Annex 113A

Description of cable clamp and test setup

Figure 113A-2—Cross-section of cable clamp

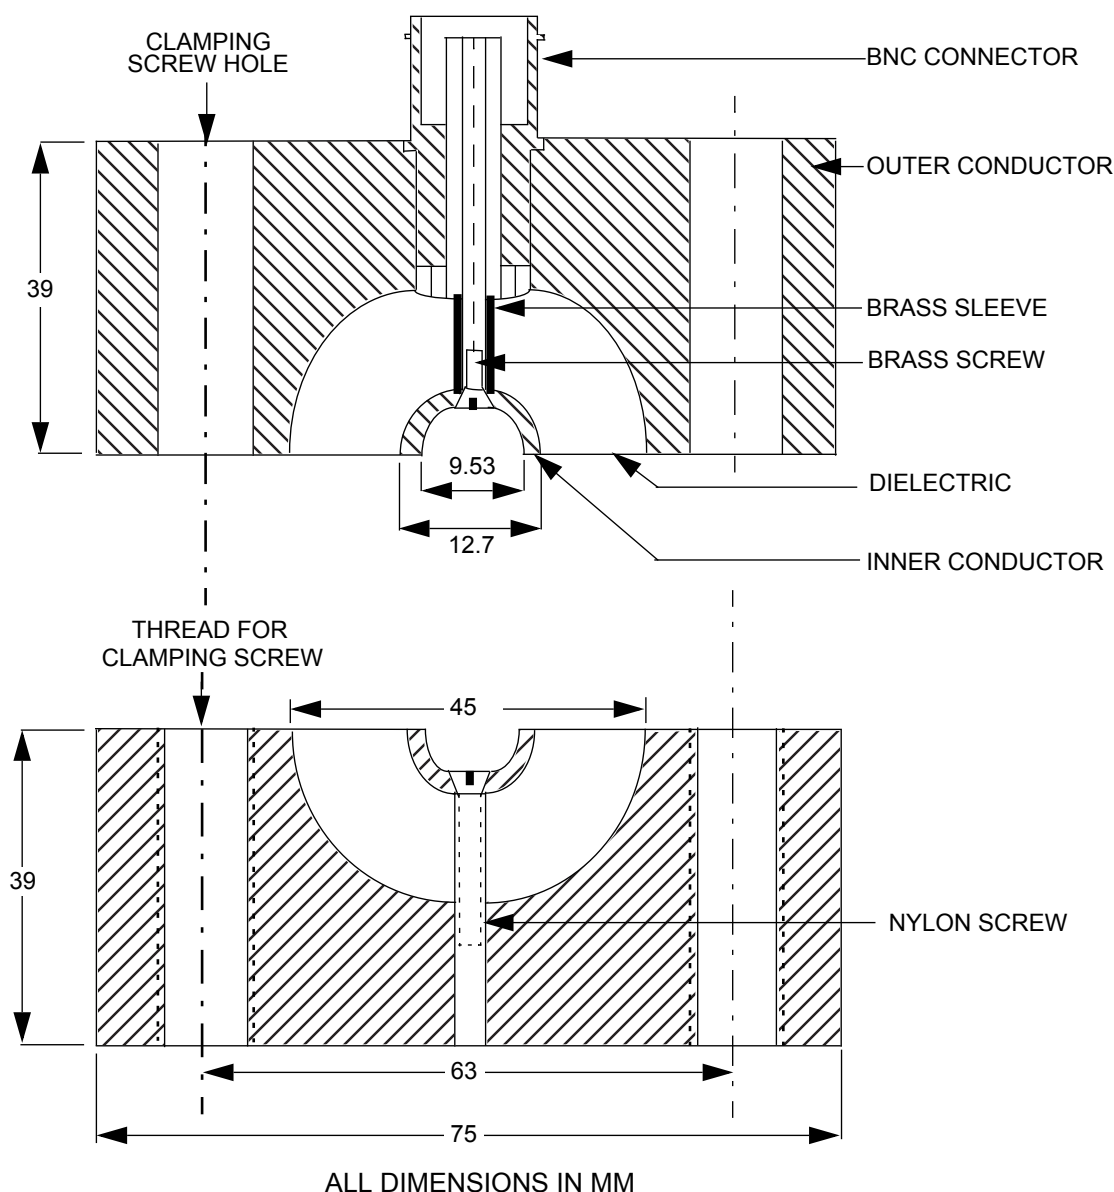
As shown in Figure 113A-2 the inner conductor on the bottom half of the clamp extends slightly (~ 0.1 mm) above the dielectric to ensure there is good electrical connection with the inner conductor of the top half of the clamp along the full length of the conductor when the two halves are clamped together.

Figure 113A-4—Cable clamp validation test configuration

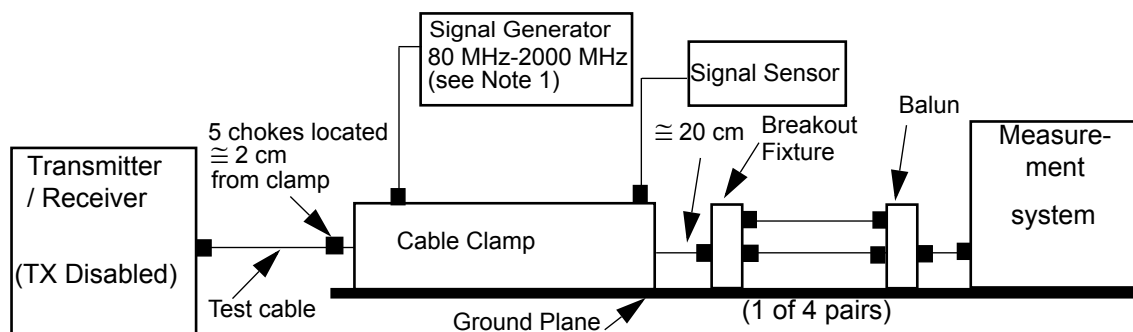
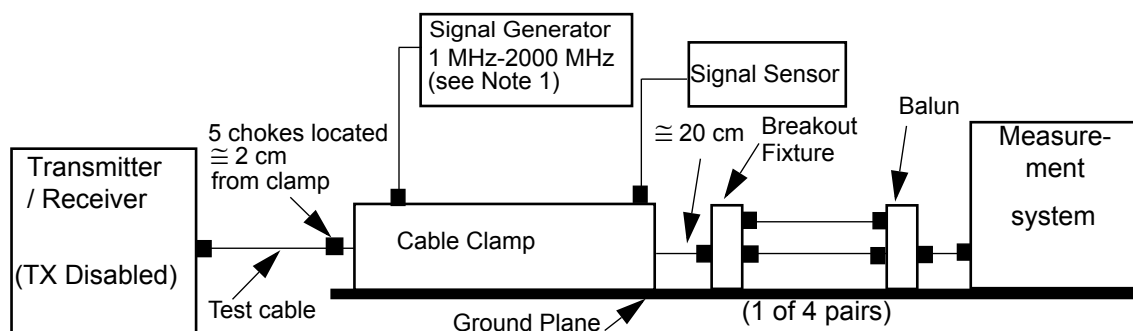
In order to ensure the cable clamp is operating correctly, the following measurement and validation procedures are provided and should be completed prior to conducting the test described in 113A.4 and illustrated in Figure 113A-4.

Cable clamp validation – This validation procedure is provided to verify proper operation of the test setup before performing any tests. In contrast to the clamp electrical measurement, the cable clamp validation test procedure uses the clamp with cabling that meets the PHY link segment specifications inserted into the clamp.

The differential-mode and common-mode voltage outputs of the balun and breakout fixture should meet the limits shown in ~~Table 113A-1~~ Table 113A-2 over the frequency range ~~80-1~~ MHz to ~~2000-2 000~~ MHz for each cable pair.

Figure 113A-4—Cable clamp test configuration

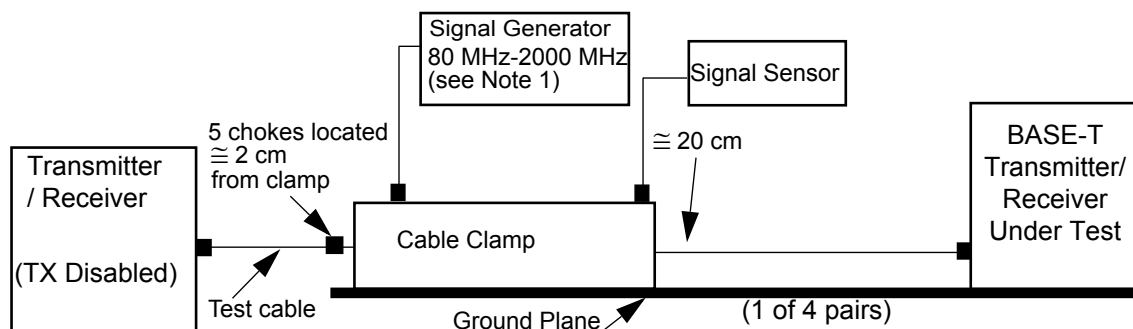
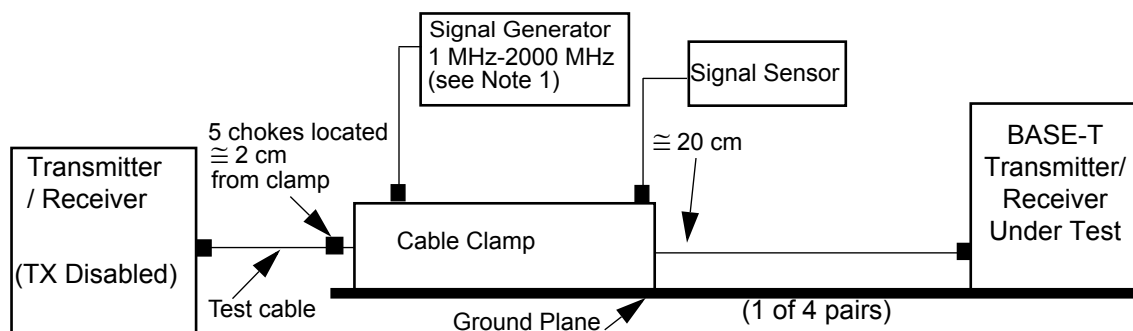
Cabling up to the maximum specified length that meets the link segment specification for the PHY under test (for example, Clause 113.7 for 40GBASE-T), is connected between two such PHYs and inserted into the cable clamp. The cable should be terminated on each end with an MDI connector plug specified for the MDI of the PHY under test (for example, Clause 113.8.1 for 40GBASE-T).

The breakout fixture and balun are replaced by the transmitter/receiver under test, with the system port positioned at the original location of the breakout. The clamp should be located a distance of ~20 cm from the receiver port.
